# Access Compliance Report

## Public Rights-of-Way

Intersection ID: 18238	Main Street: QUEEN ANNE RD	Cross Street: S TRYON ST	Location:	N
ADA ID: 7E33017D891D	Ramp Type: Perp	Initial Pass/Fail: Fail	Overall Compliance: No	Severity Score: 12.5

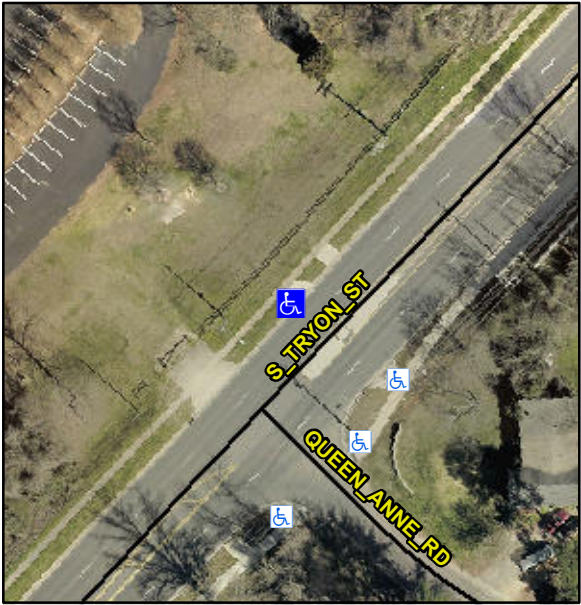
Codes/Mitigation Info/Possible Solution			Field Measurements/Component Compliance		
	Possible Solutions:		<b>Compliance</b>	<b>Description</b>	<b>Data</b>
	Remove & Replace Entire Ramp.		N/A	Ramp Length (in)	96.0
			Yes	Ramp Width (in)	72.0
			N/A	Flare Type LT	N/A
			N/A	Flare Slope LT (%)	N/A
			N/A	Flare Traversable LT?	N/A
			N/A	Landing Length (in)	N/A
			N/A	Landing Width (in)	N/A
			N/A	Landing Slope (%)	N/A
			N/A	Landing X Slope (%)	N/A
<p>Surveyor Notes:</p> <p>N/A</p> <p>PROW/ADA:</p> <p>R304.2.2</p>			N/A	Flare Type RT	N/A
			N/A	Flare Slope RT (%)	N/A
			N/A	Flare Traversable RT?	N/A
			N/A	DWS Provided?	N/A
			N/A	DWS Contrast?	N/A
			N/A	DWS Length (in)	N/A
			N/A	DWS Full Width?	N/A
			N/A	DWS Offset (in)	N/A
			N/A	Gutter Ponding?	N/A
			N/A	Gutter Lip Ht (in)	N/A
			N/A	Painted X Walk1?	No
				X Walk 1 Direction	To SE
			N/A	X Walk 1 Width (in)	N/A
				X Walk 1 Slope (%)	0.9
				X Walk 1 X Slope (%)	0.6

N/A	Ramp inside XWalk1?	N/A
				Road Slope (%)	N/A
				Road X Slope (%)	N/A
			N/A	Any Obstructions?	N/A
				Obstruction Type	
Total Cost:					
			\$	1850.00	
			N/A		N/A
			Yes	Surface Condition? (G/P)	Good
